GREENWOOD TOWNHOMES

10512 GREENWOOD AVENUE NORTH

ADMINISTRATIVE DESIGN REVIEW RECOMMENDATION

0#.#.#.19 | MUP # 3030207-LU

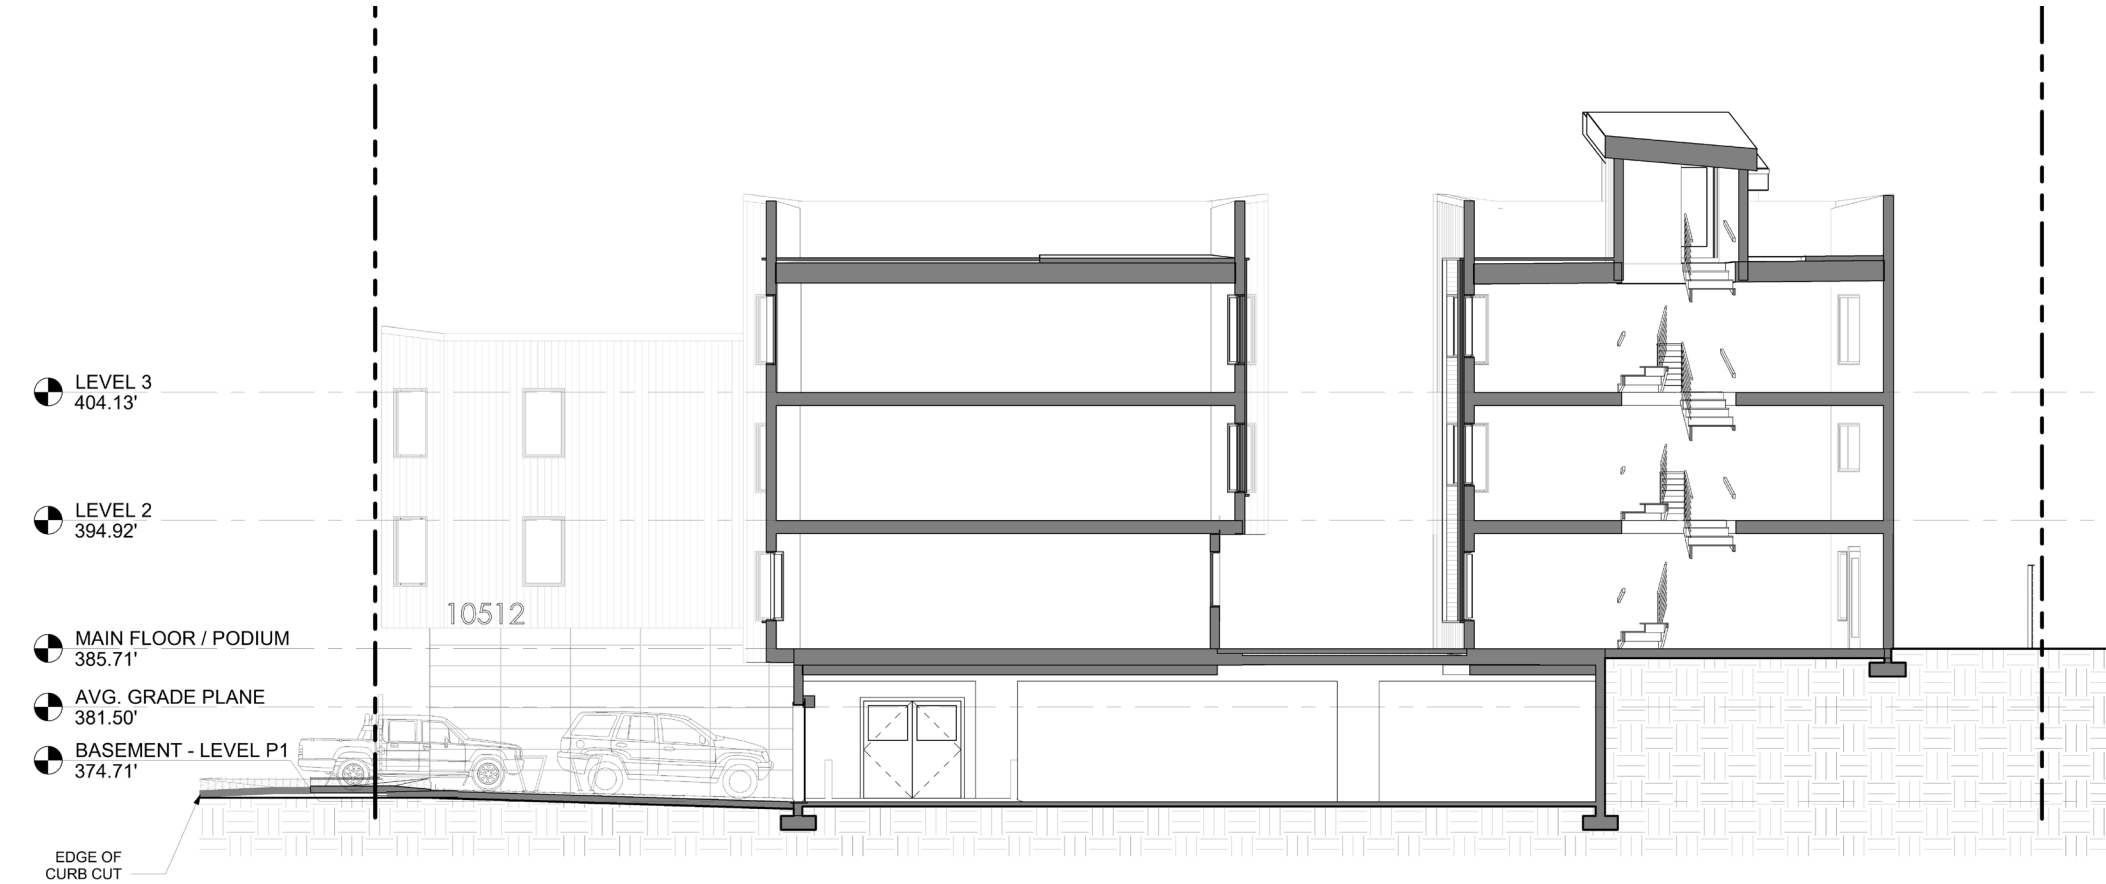
The Board was concerned about vehicular queuing on Greenwood Avenue N due to the narrow width of the driveway. While the Board encourages the width of the driveway to remain as narrow as possible, the applicant is directed to study how vehicular queuing on Greenwood Avenue N can be avoided or minimized. (PL4-A-1)

Per the section there is enough room to accommodate two and a half large vehicles while waiting for access to the garage.

OPTION 3D - EDG

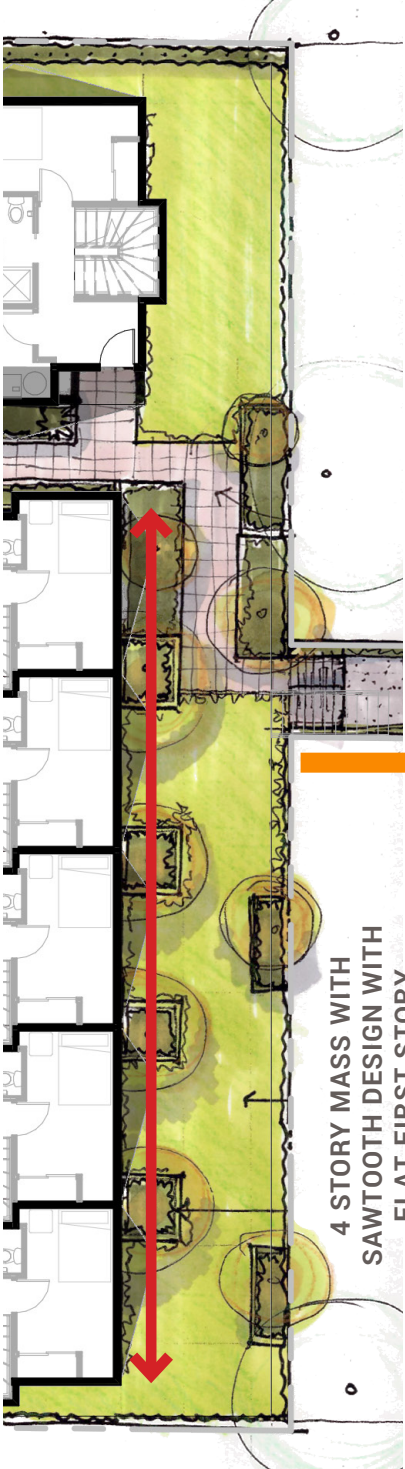
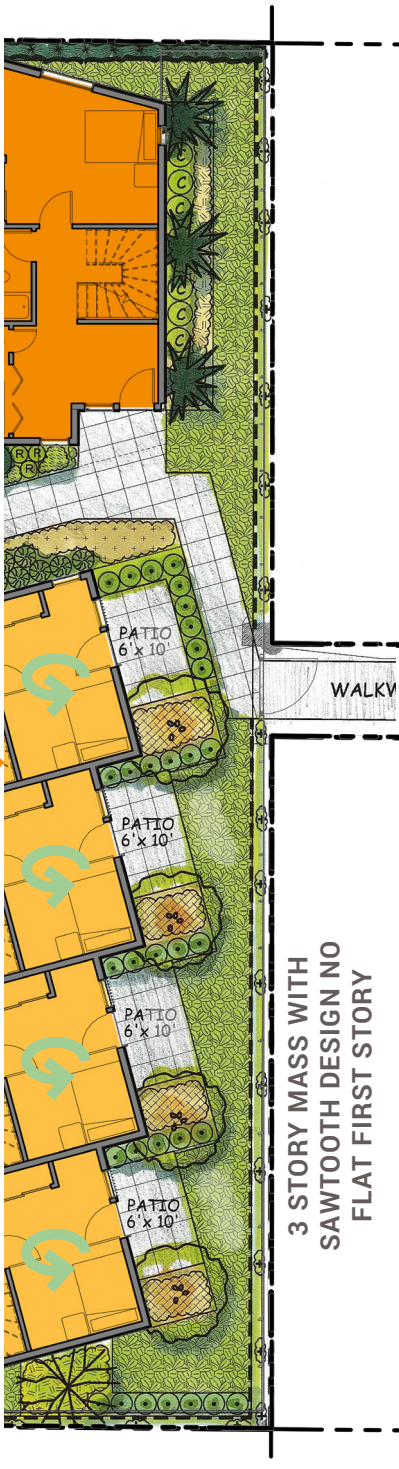
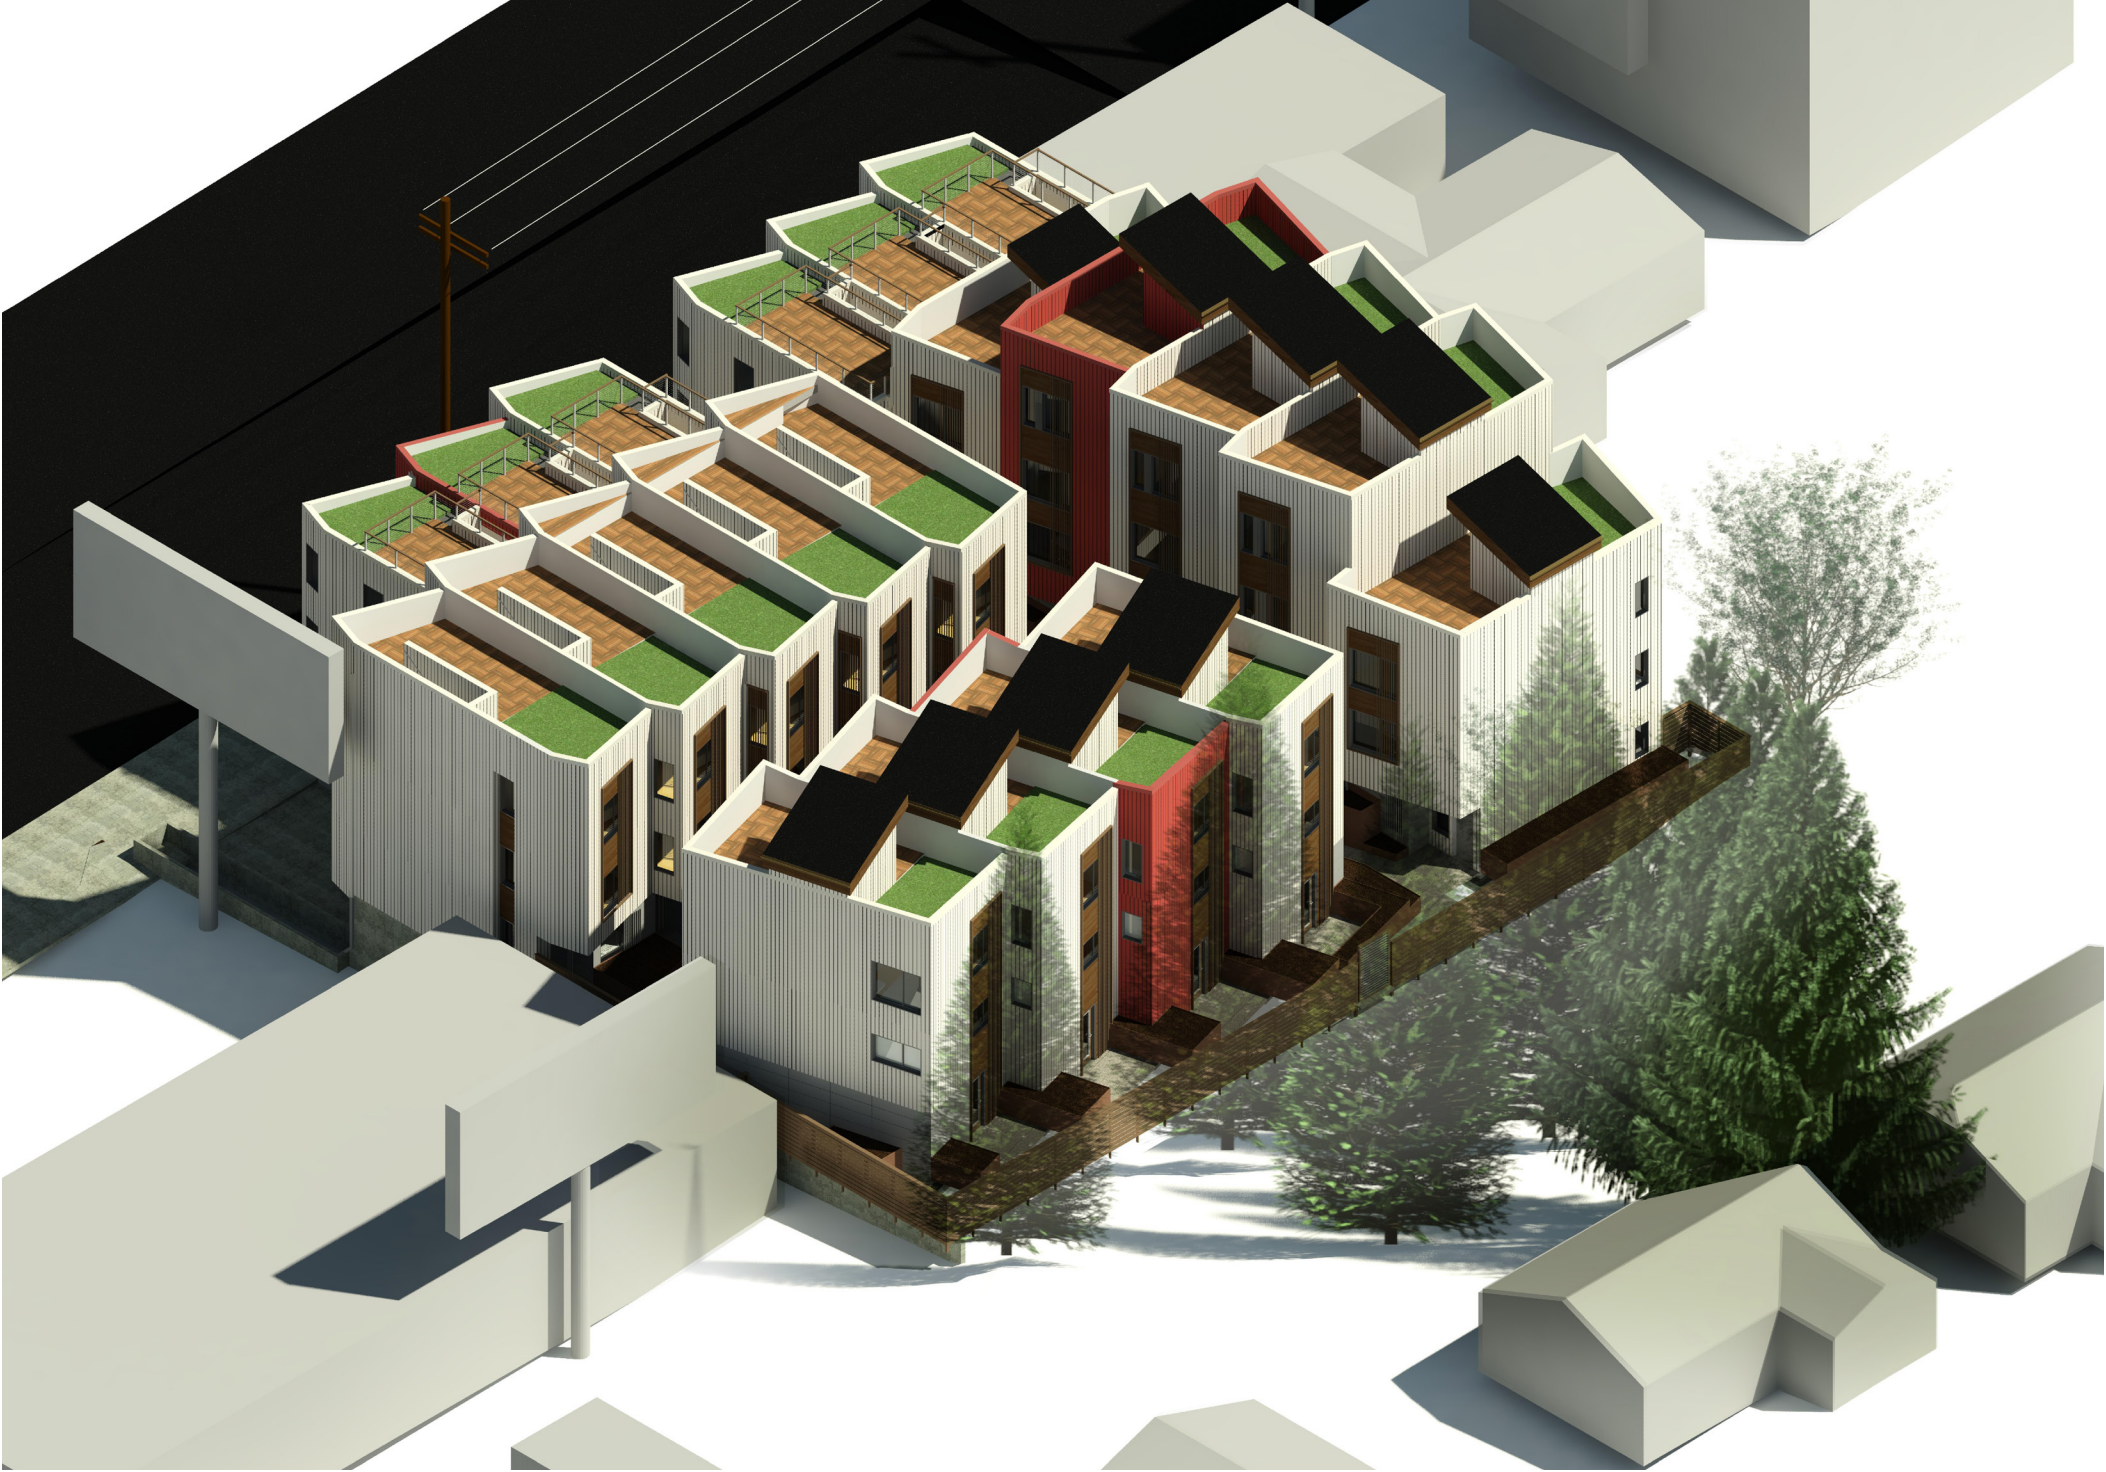
C) The Board was concerned about the four-story massing at the rear which abuts a single-family zone. While the use of landscape screening or facade modulation can assist with the transition to the single-family zone, the Board stated that these methods are insufficient on their own and that building mass must also be shifted away from the eastern property line. (CS2-D)

The massing was reduced from 6 units at 4 stories each to 5 units at 3 stories each. In addition the flat facade was skewed to pull the mass away from the Eastern PL and the units were lowered 1'-2" (9.5" podium drop and 4.5" unit height drop). Patio landscaping has been added to ease the transition to single-family zone at the rear of the site.

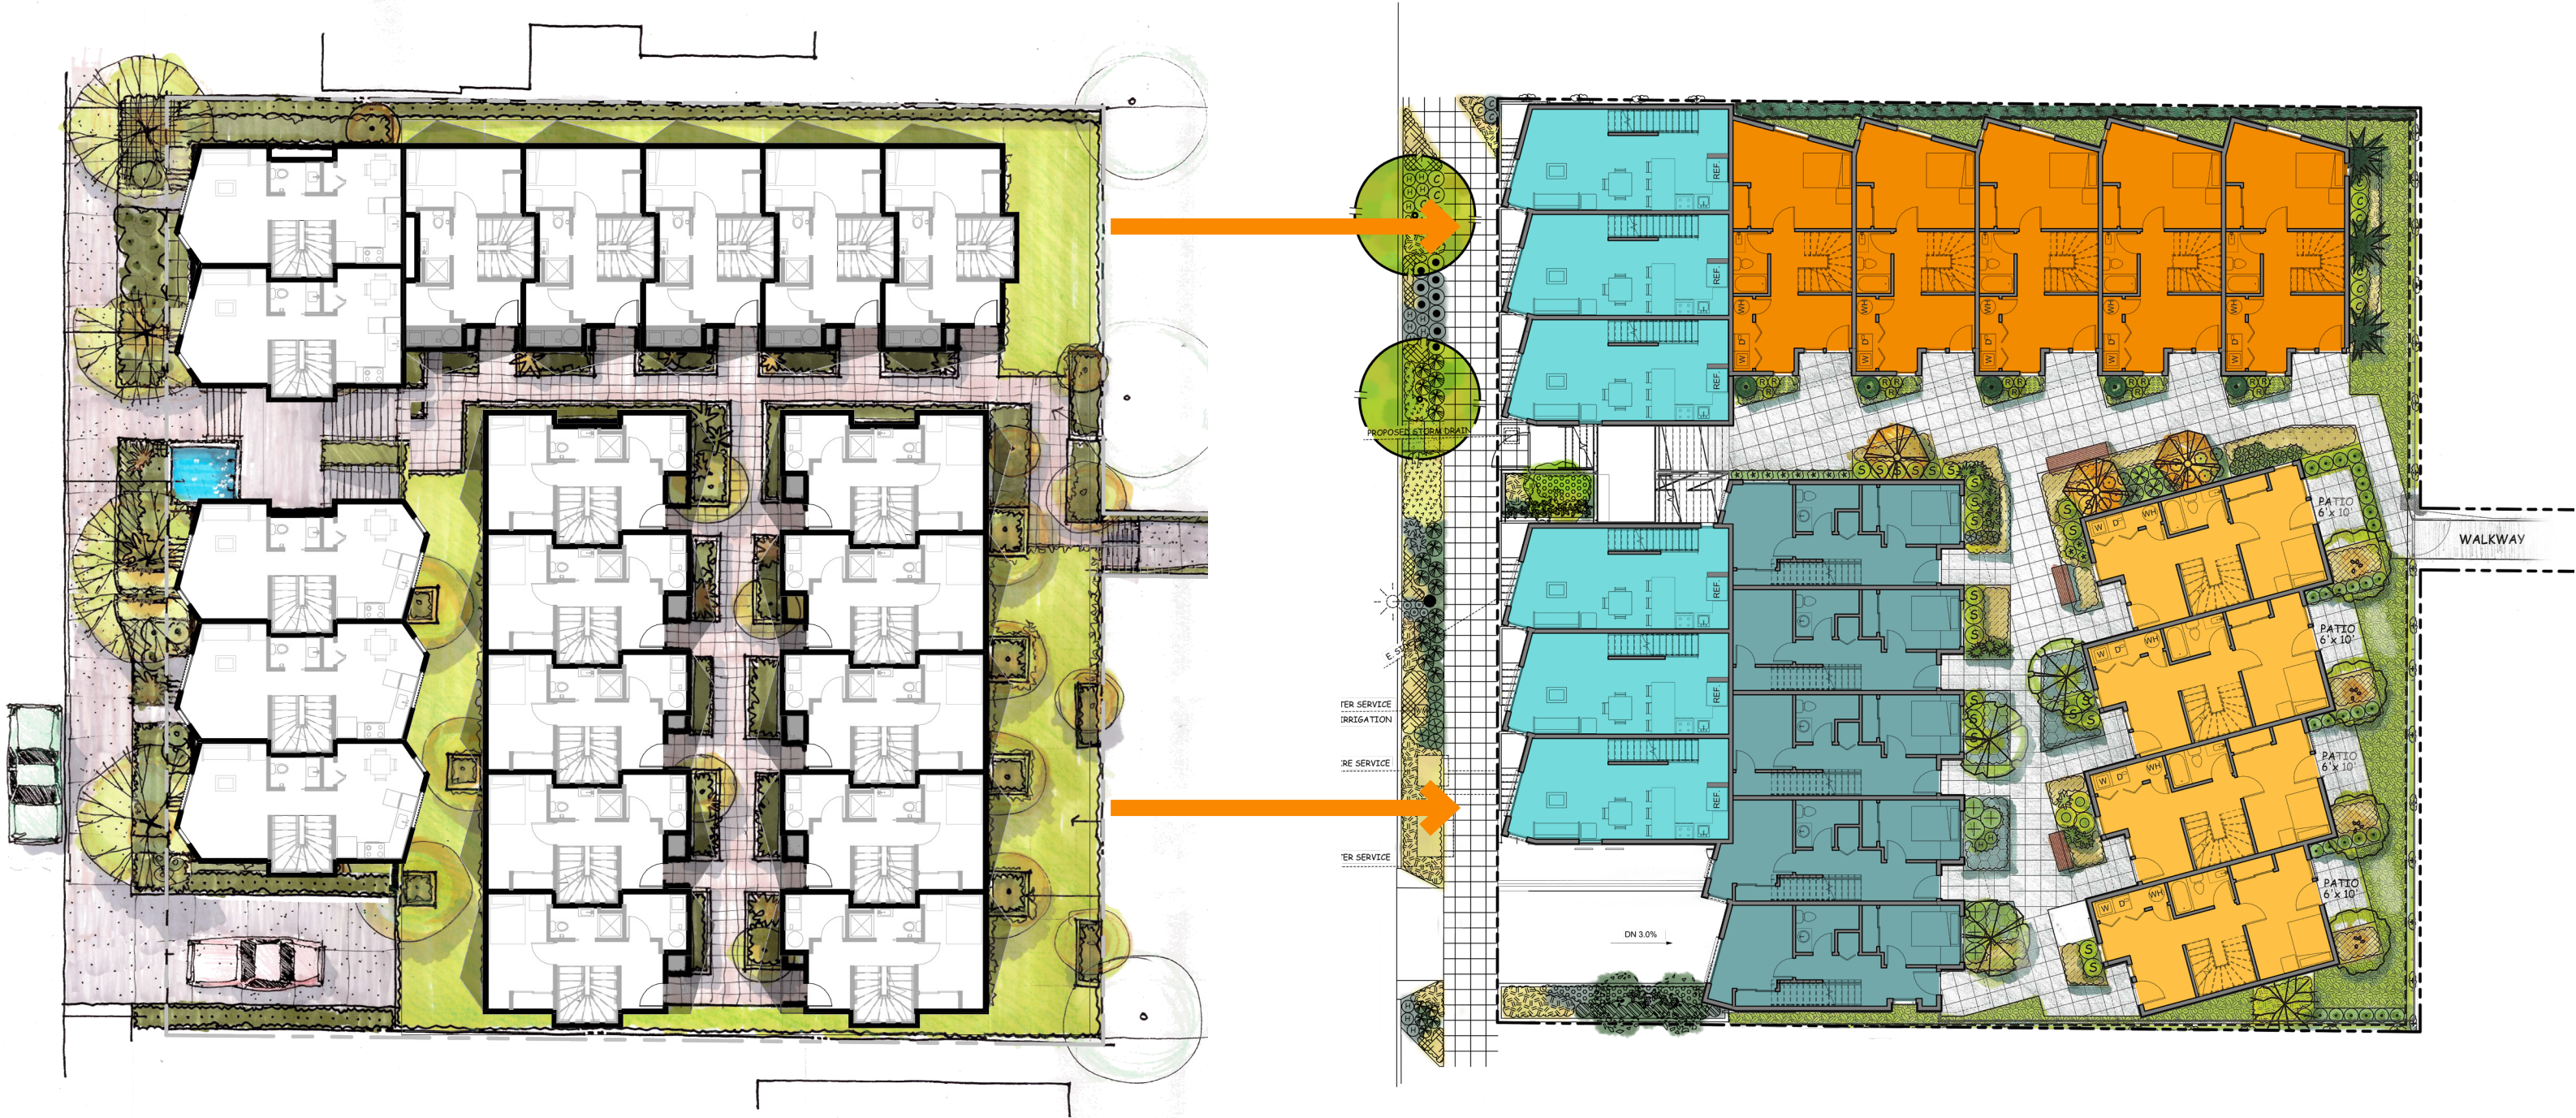
A) The Board was concerned about the narrowness of the pedestrian pathways, particularly in Option 3. The sawtooth design shown in the “further development” Option 3-D further exaggerates this narrowness and needs to be thoughtfully designed to create a sense of space and openness between buildings. (DC2-A)

A) The Board noted that the sawtooth design concept adds interest to the facade and results in better privacy relationships between buildings. However, as mentioned above, the Board was concerned about the effect of the sawtooth concept with regard to the narrow pedestrian pathways. The Board supported the use of the sawtooth design concept, but stated that it is not successful as currently shown. (CS2-D-5,DC2-C)

The two narrow pedestrian pathways now have wider paths with multiple branches to allow for a larger feel, areas of privacy yet connection with neighbors in mingling spaces.
